ADDENDUM NO. 1

April 14, 2022

YOST ELEMENTARY SCHOOL ADDITIONS AND RENOVATIONS Chesterton, IN 46304

Addendum One (AD.01) to the drawings and specifications prepared by Gibraltar Design for **New Yost Elementary School** for Duneland School Corporation, Chesterton, Indiana.

8 EAVE DETAIL
A-211 1 1/2" = 1'-0"

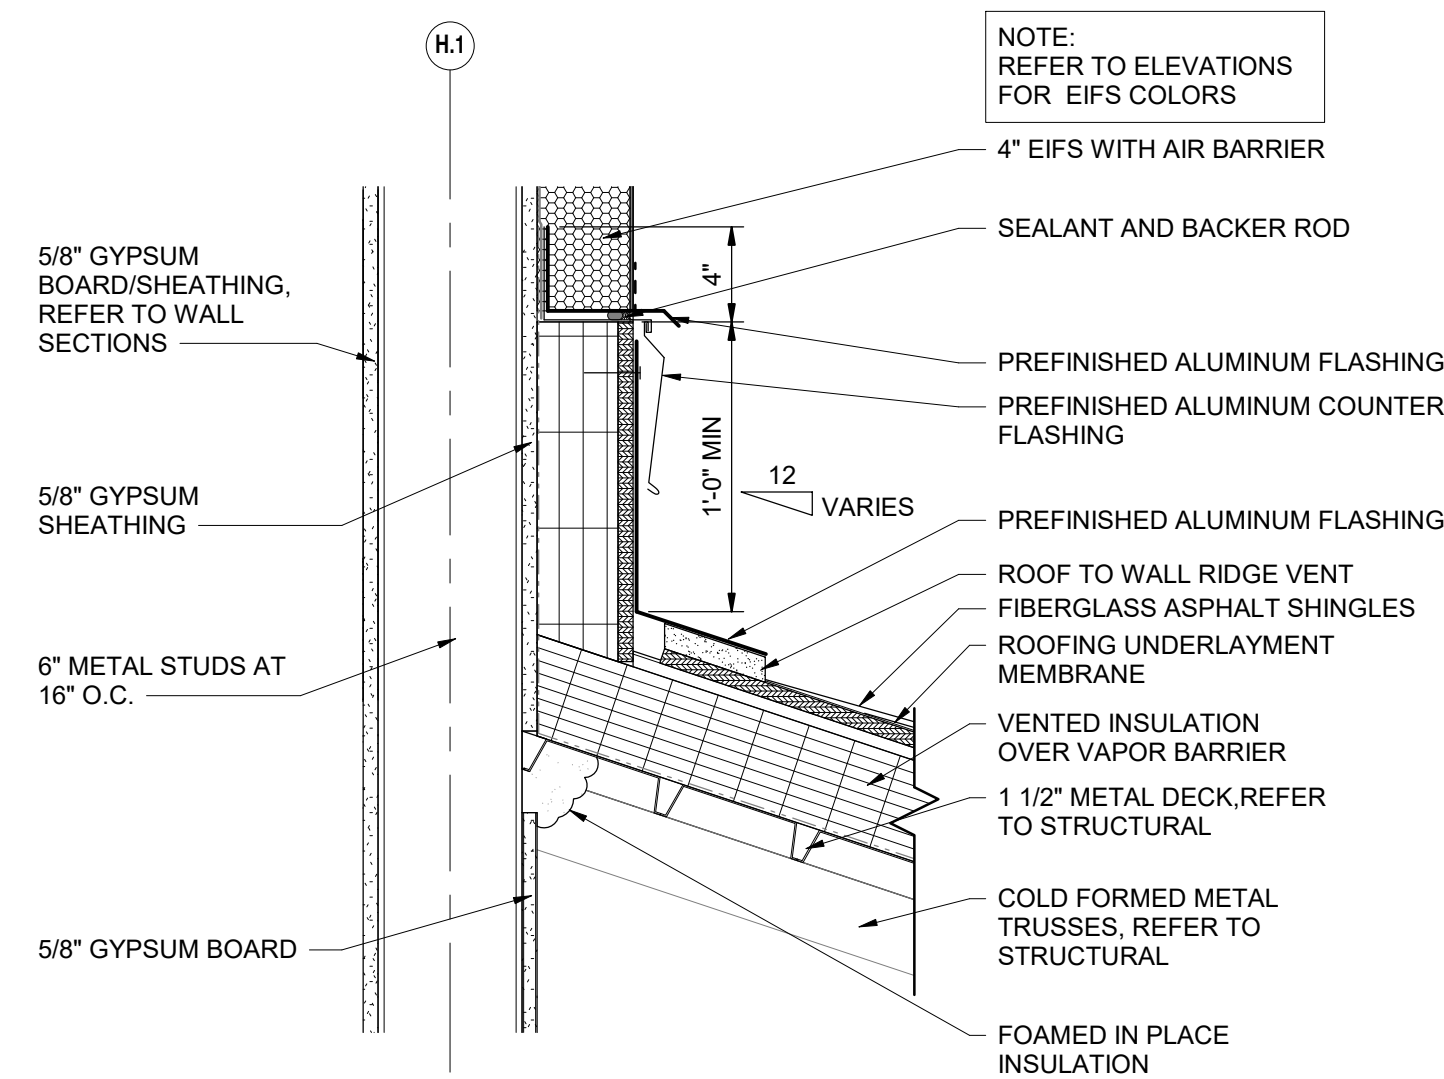
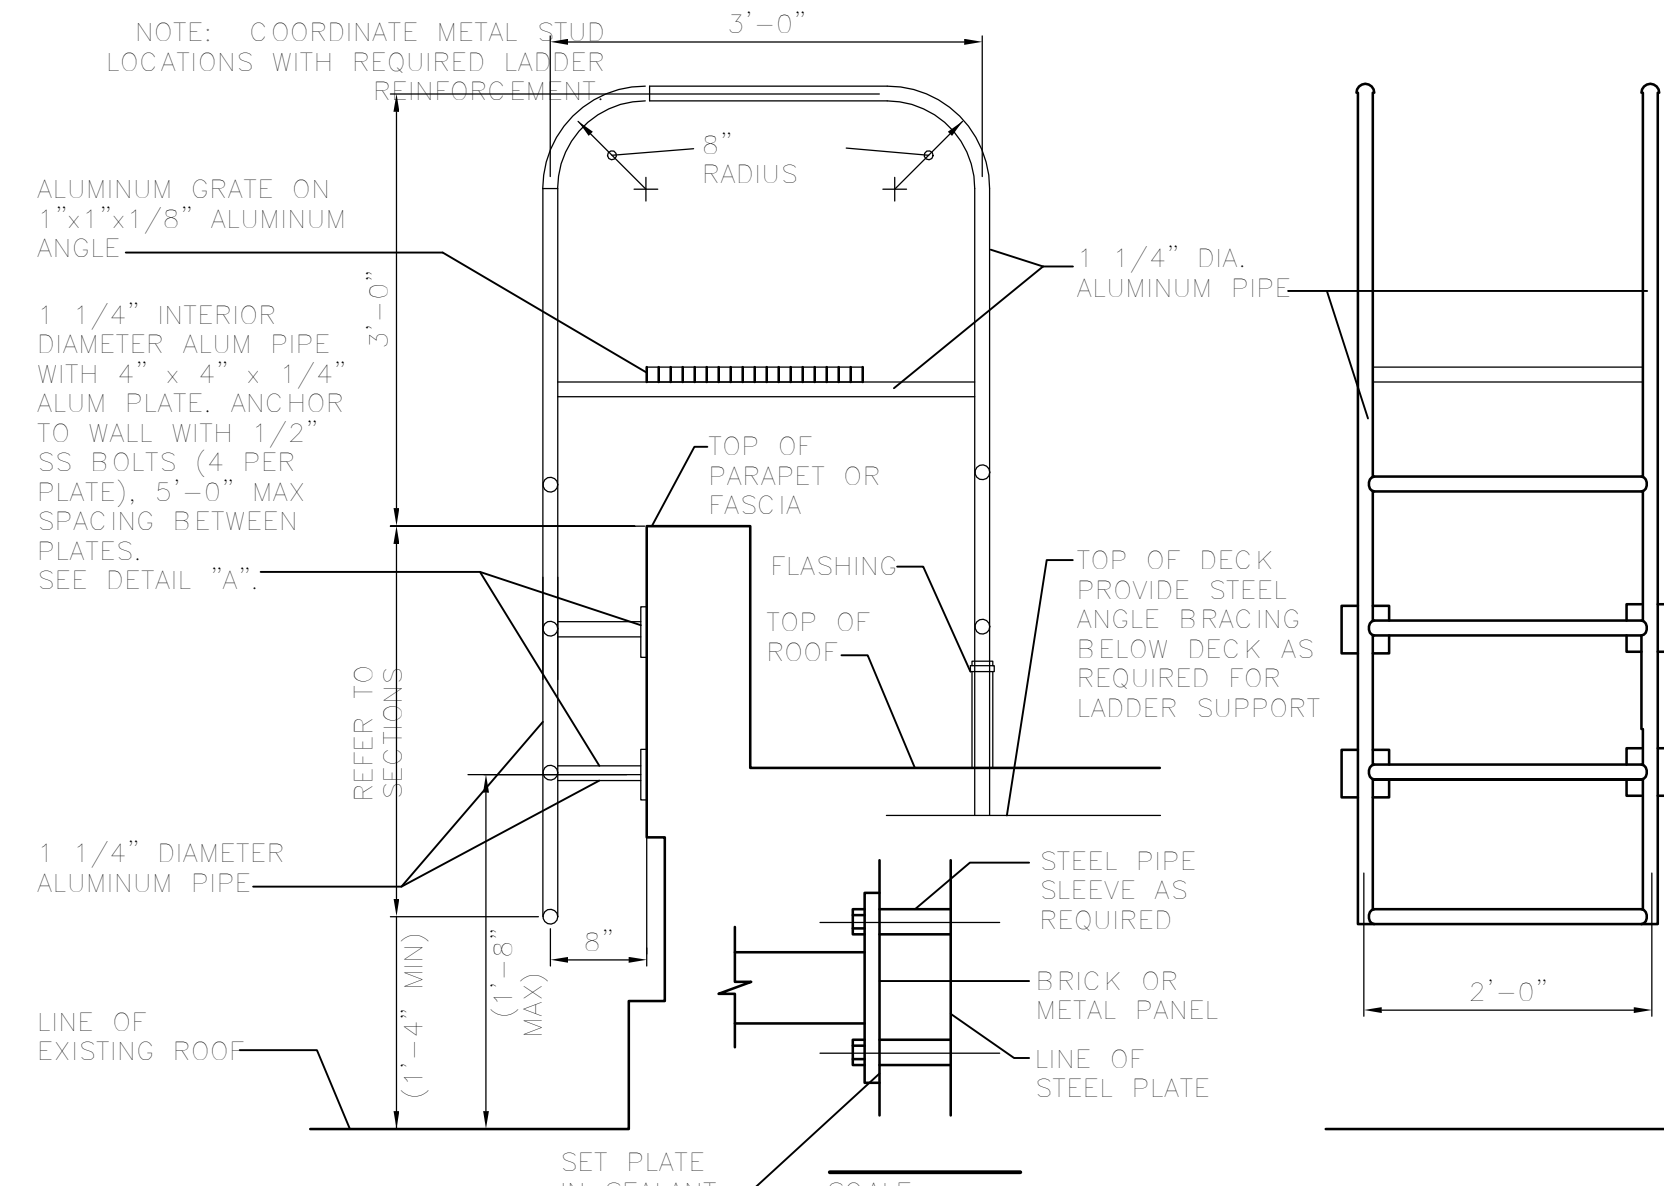
12. Sheet A-211

- A. Refer to revised full size drawing, included in this Addendum, for the following revisions:
 - 1. Eave Detail 8/A-211: Clarify masonry coursing and add cavity vent at top of masonry.

A-413

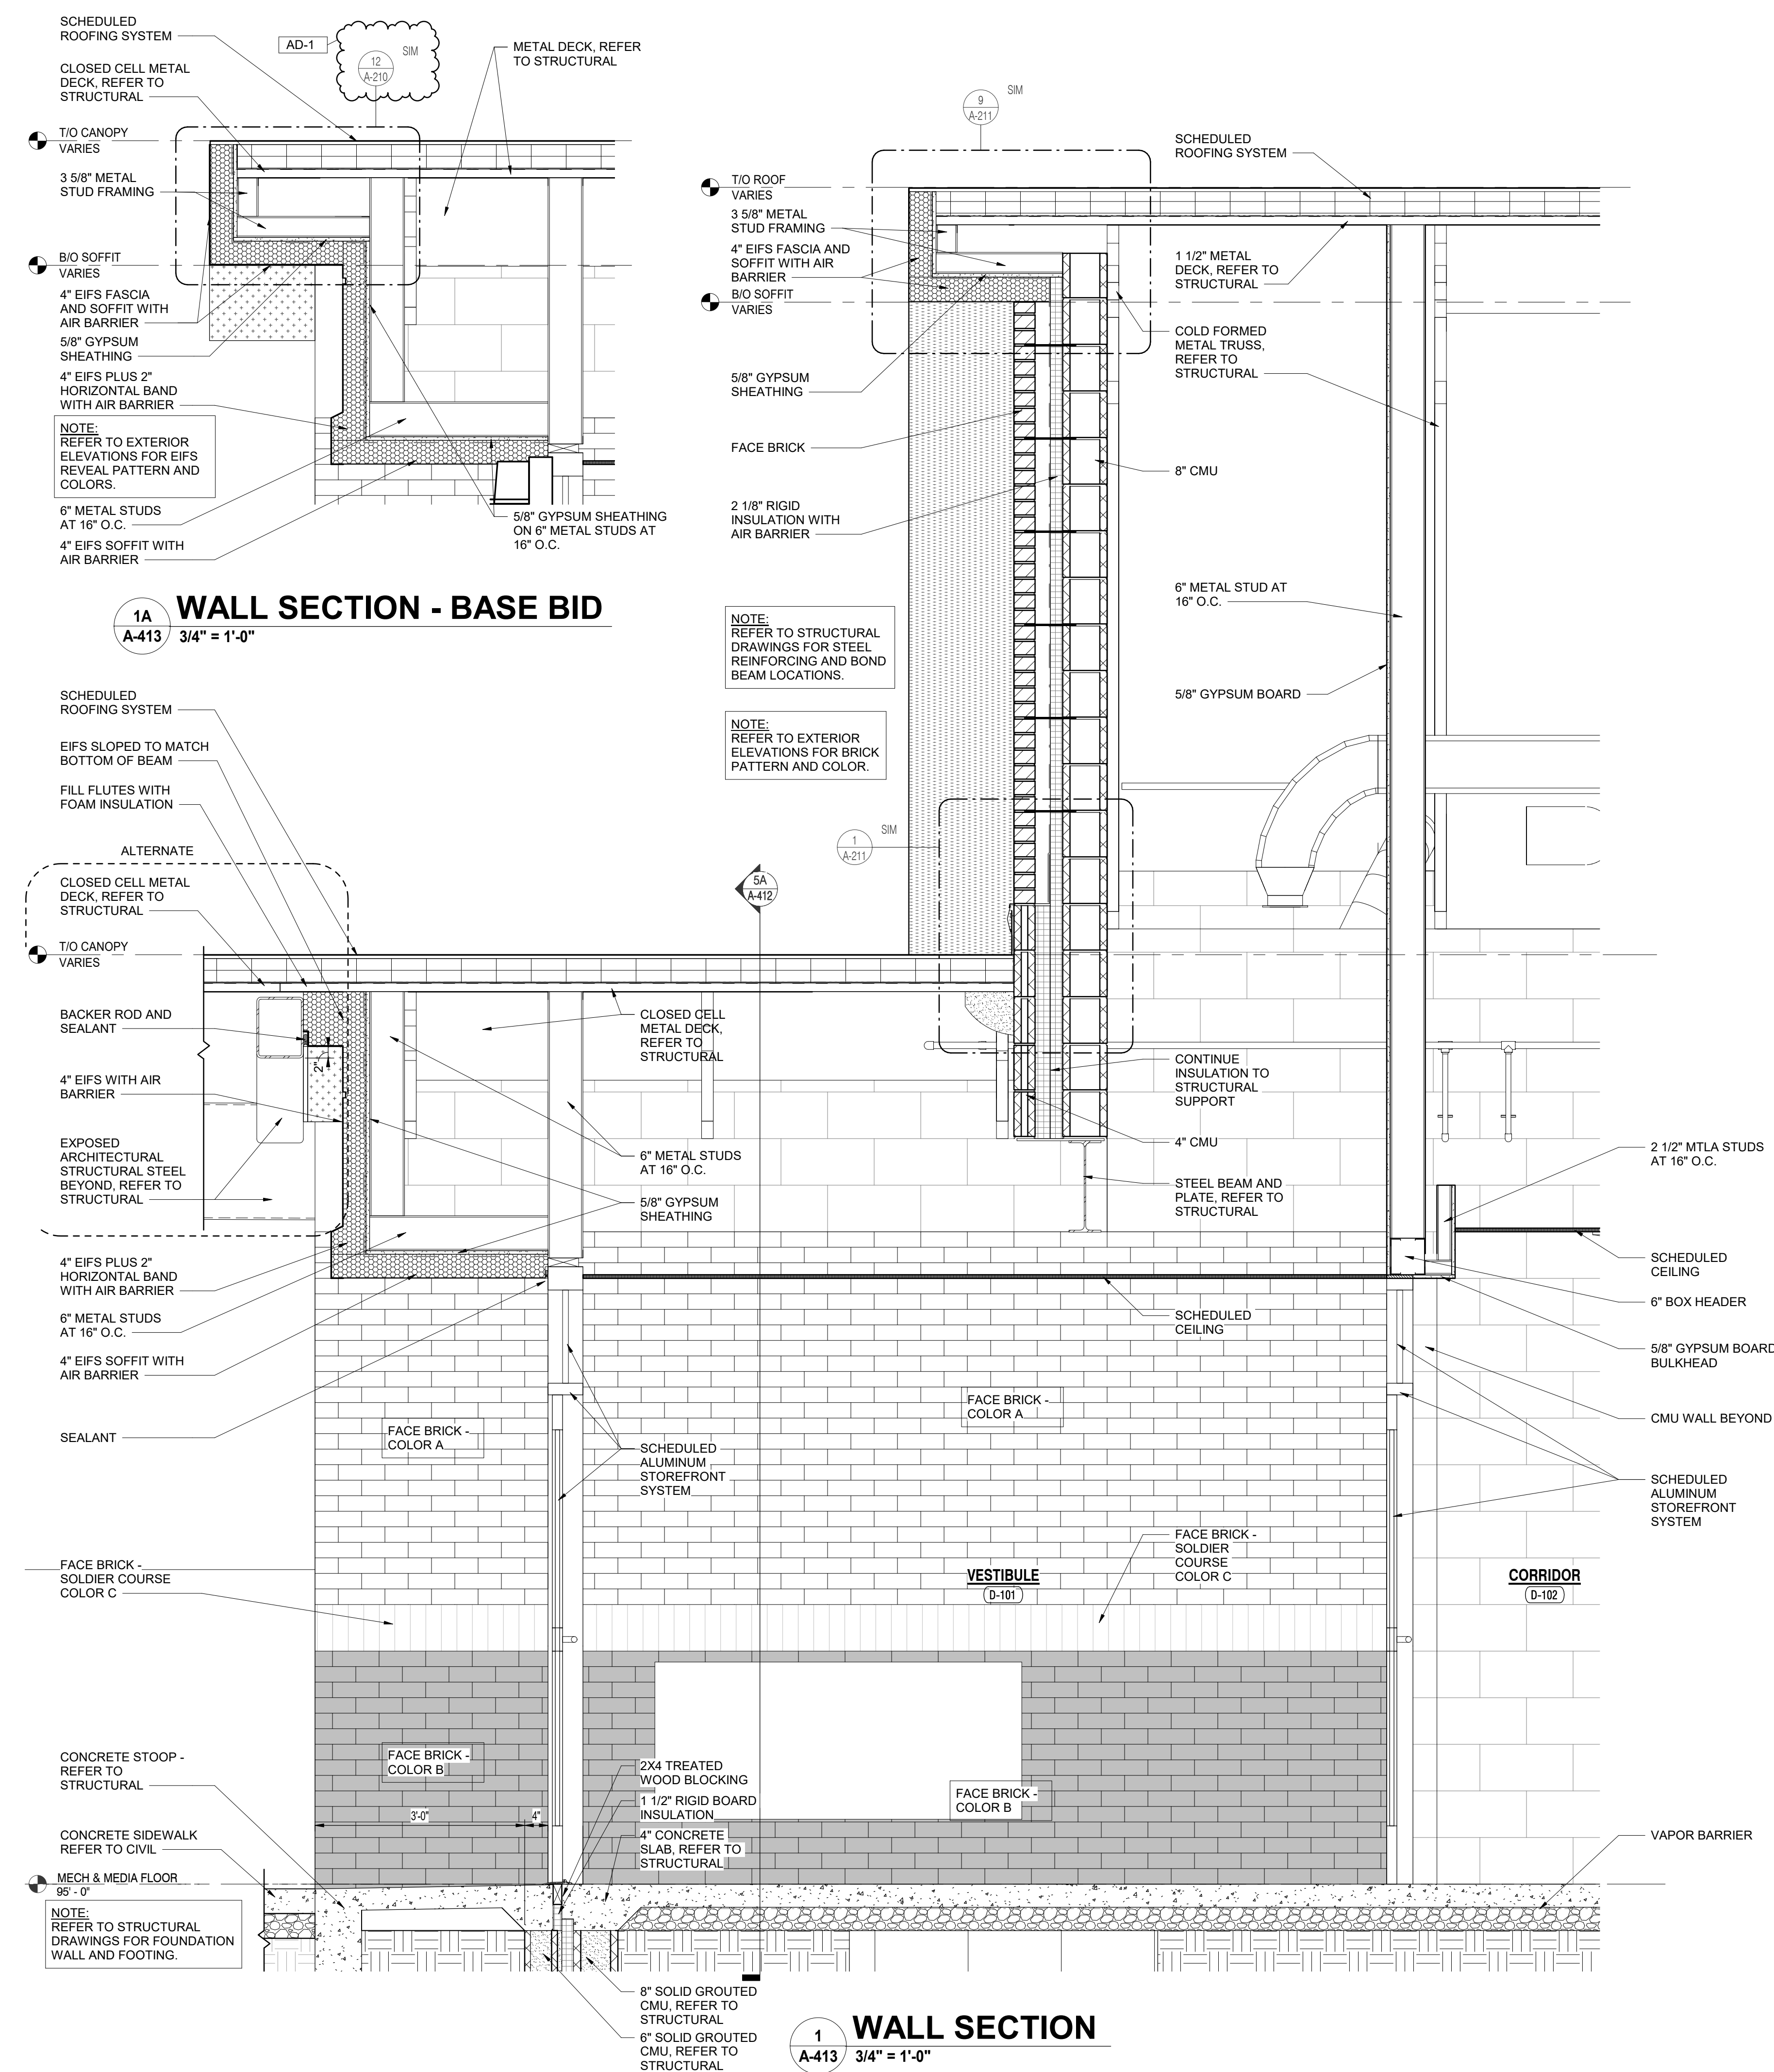
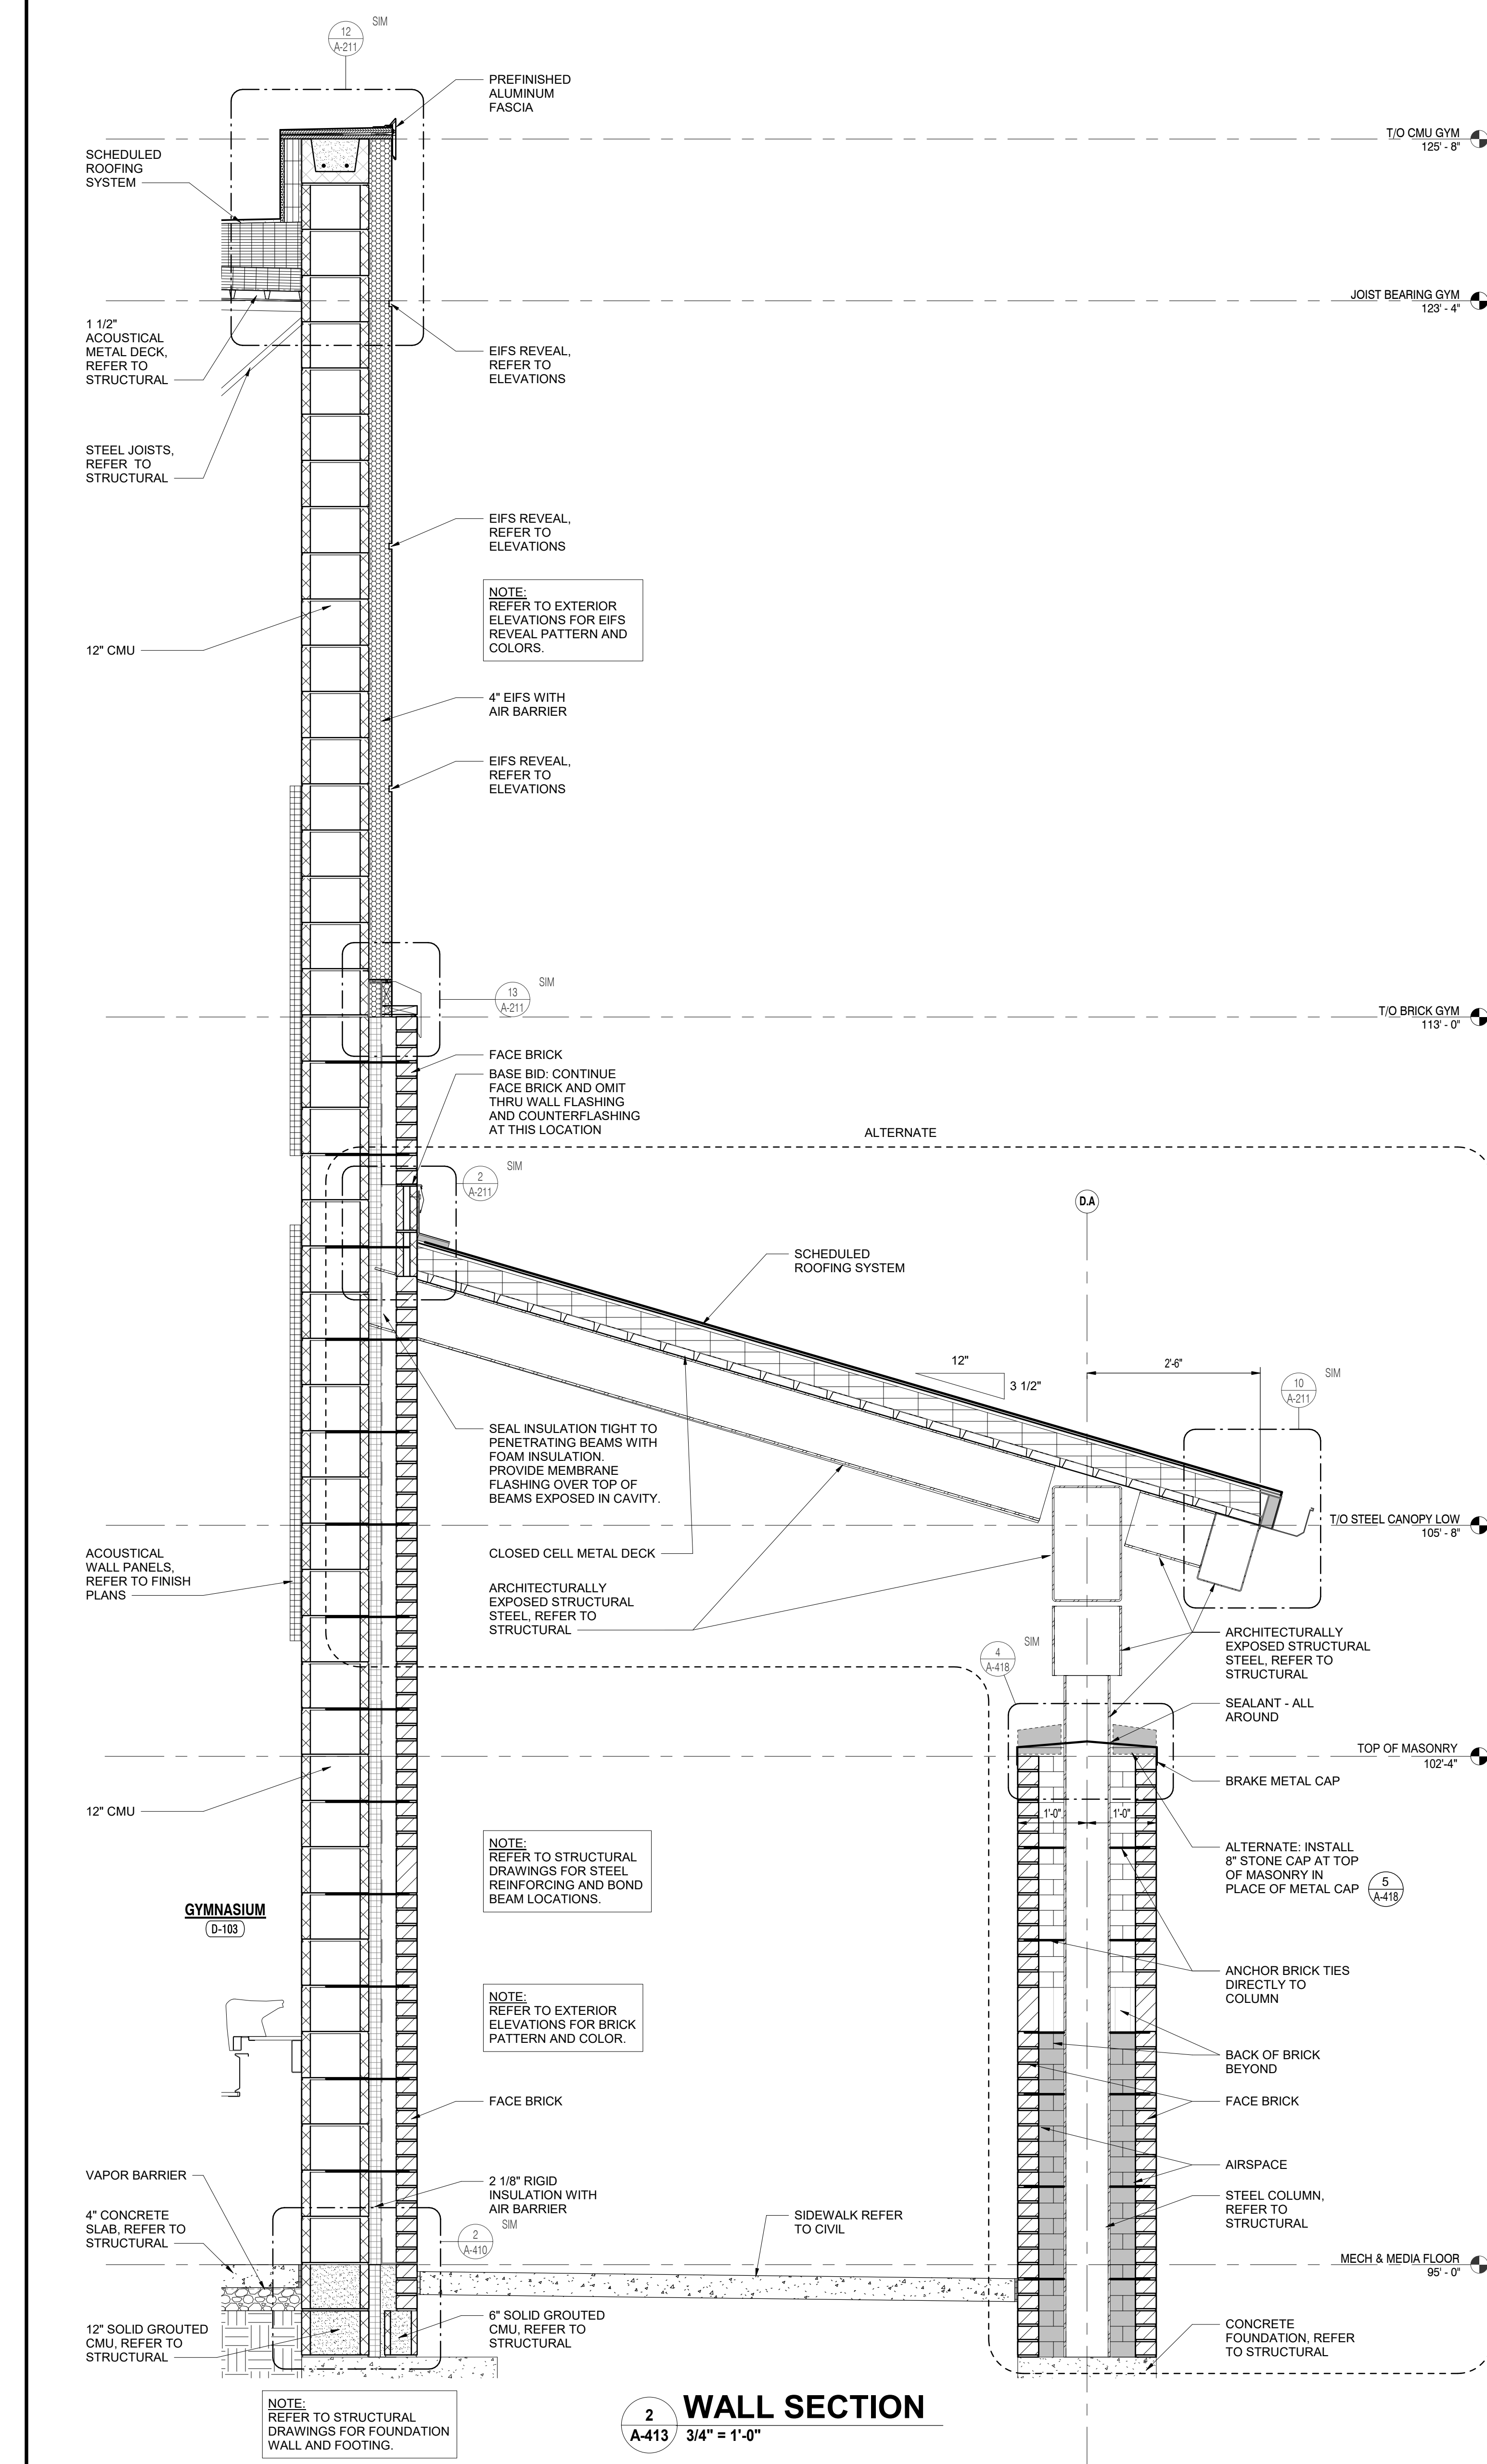
14. Sheet A-413

- A. Refer to revised full size drawing, included in this Addendum, for the following revisions:
 - 1. Wall Section Base Bid 1A/A-413: Change enlargement callout from 2/A-211 to 12/A-210.
